Aura Lakes Precinct Engineering Services Report Precinct 18 – First Development

PLANS AND DOCUMENTS referred to in the PDA DEVELOPMENT APPROVAL

Response to Further Issues Letter

Further to the Further Issues Letter provided by Economic Development Queensland dated 29 May 2024 and subsequent meetings we provide the following responses to engineering items raised:

Figure 6-2 Proposed Stormwater Plan

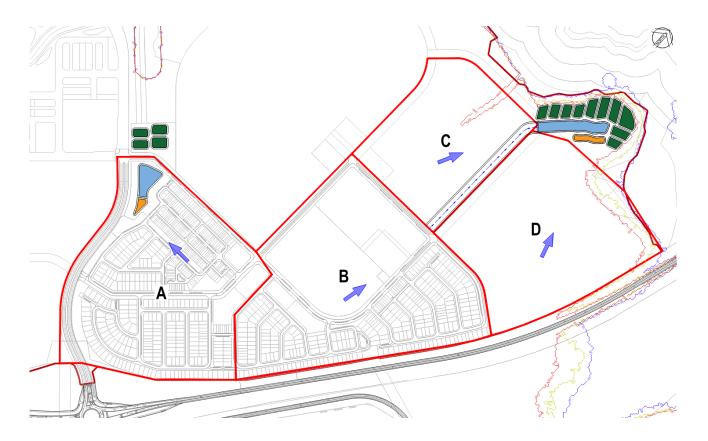
Further Issues Letter Item	Description	Response
9 (d)	Referring to Drawing SK1300, Catchment B is required to be discharged into an open drain in accordance with the LGIA, Infrastructure Network 4, Table 3. Catchment B is larger than 30Ha.	In accordance with the updated engineering drawings and section 6.2.1 of this report an open channel has been provided for the Catchment B stormwater discharge as requested. The integration of this open channel into the future development works is to be reviewed under cover of further design works for the subsequent precints.
9 (e)	Catchments B, C and D drain into the same wetland bio-retention basin. An interim HES basin catering for Catchment B post dwelling construction is not appropriate. There is no certainty regarding the timing of the WSUD basin. As an alternative, Catchment B is to be discharged into a partly constructed WSUD basin. Other 'cells' of the WSUD basin can be constructed at a later date when Catchment C and D are developed.	As discussed in section 6.2.1 of this report a staged delivery of the WSUD basin to cater for the requirements of Catchment B has been acknowledged as requested.

Catchment B is greater than 30 hectares. In accordance with the provisions of the Local Government Infrastructure Agreement it is required to be discharged into an open channel which is reflected in the engineering design documentation. Investigation into the incorporation of this channel into future piped drainage solutions or as an open channel within the future development catchments C and D are to be investigated under cover of future applications.

It is noted that Catchment B discharges towards a future WSUD basin which will ultimately cater for flow from catchments C and D also as part of an end of line treatment system. Investigation is to be completed into the staged delivery of the WSUD basin in order to allow for early establishment for the purposes of treating outflows from Catchment B as a 'partly' constructed WSUD basin. Other cells of the WSUD basin can be constructed at a later stage when Catchments C and D are developed.

Drawing No. 304701171-100-CD-SK1135

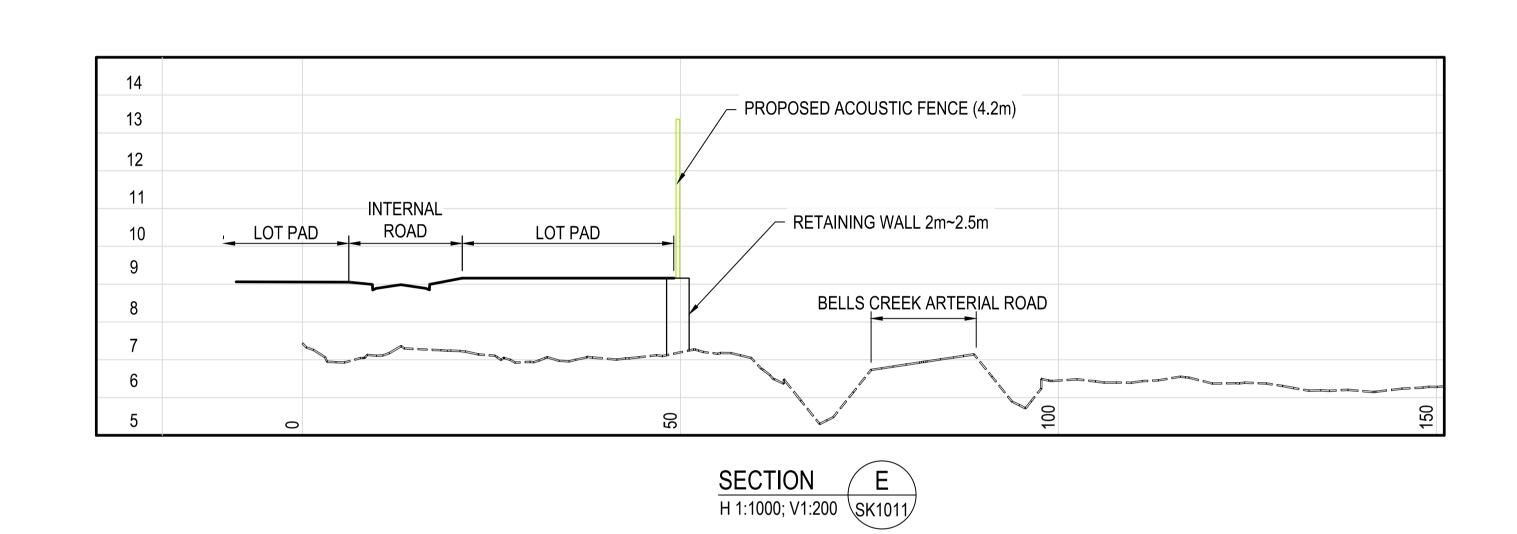
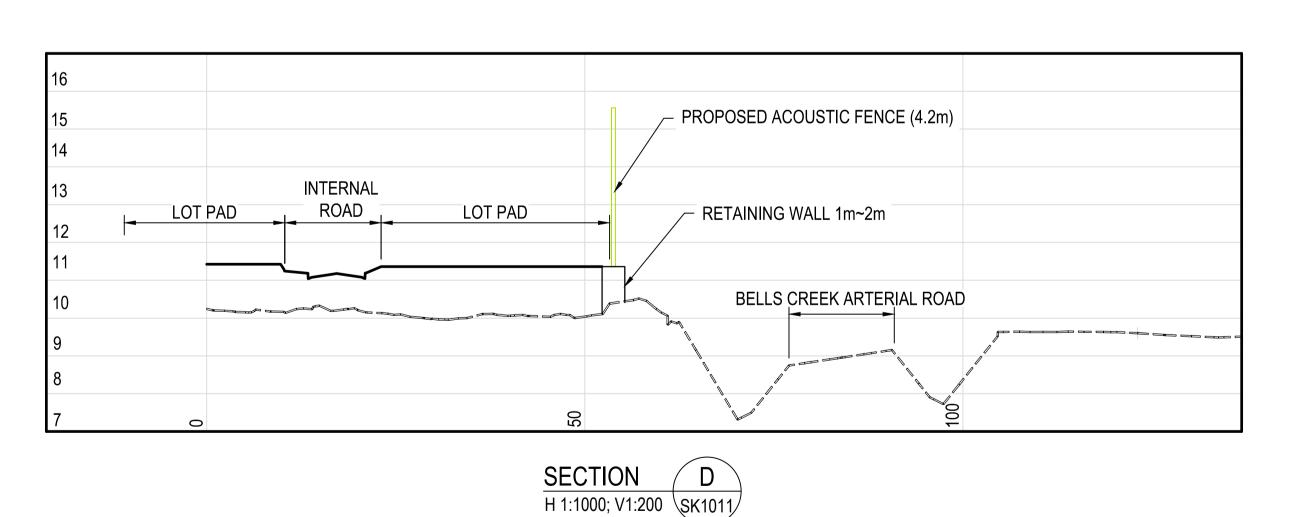
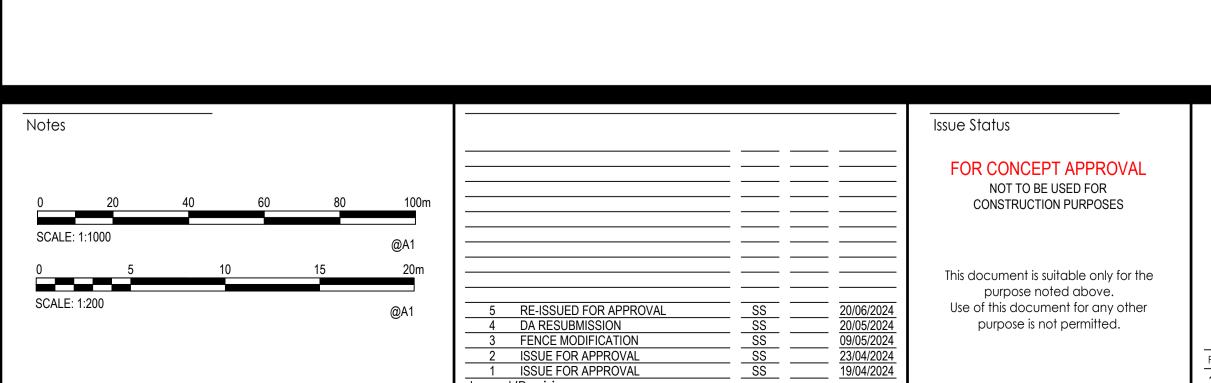
Further Issues Letter Item	Description	Response
2 (b) (iii)	Provide a revised lot layout and bulk earthworks strategy / lot grading plan that reduces the overall heights of retaining walls and acoustic fence treatment. Retaining walls should be a maximum of 2.5m tall, with a preference for tiered structures taller than 1.5m.	Revised earthworks design has been provided as detailed on drawing SK1010 with retaining wall heights included within the engineering design detailed on drawing SK1011. Proposed retaining wall details are discussed in section 3.4 of this report.
2 (b) (iv)	For inclusion in the Engineering Services Report, provide detailed sections (top of wall RL) at any fence height change intervals along the proposed acoustic attenuation areas (i.e. overall retaining wall and acoustic fence combined).	Cross-sections and a detailed elevation of the proposed retaining wall and acoustic barrier configuration at the interface of the development site and Bells Creek Arterial is included within drawings SK1135 to SK1137.
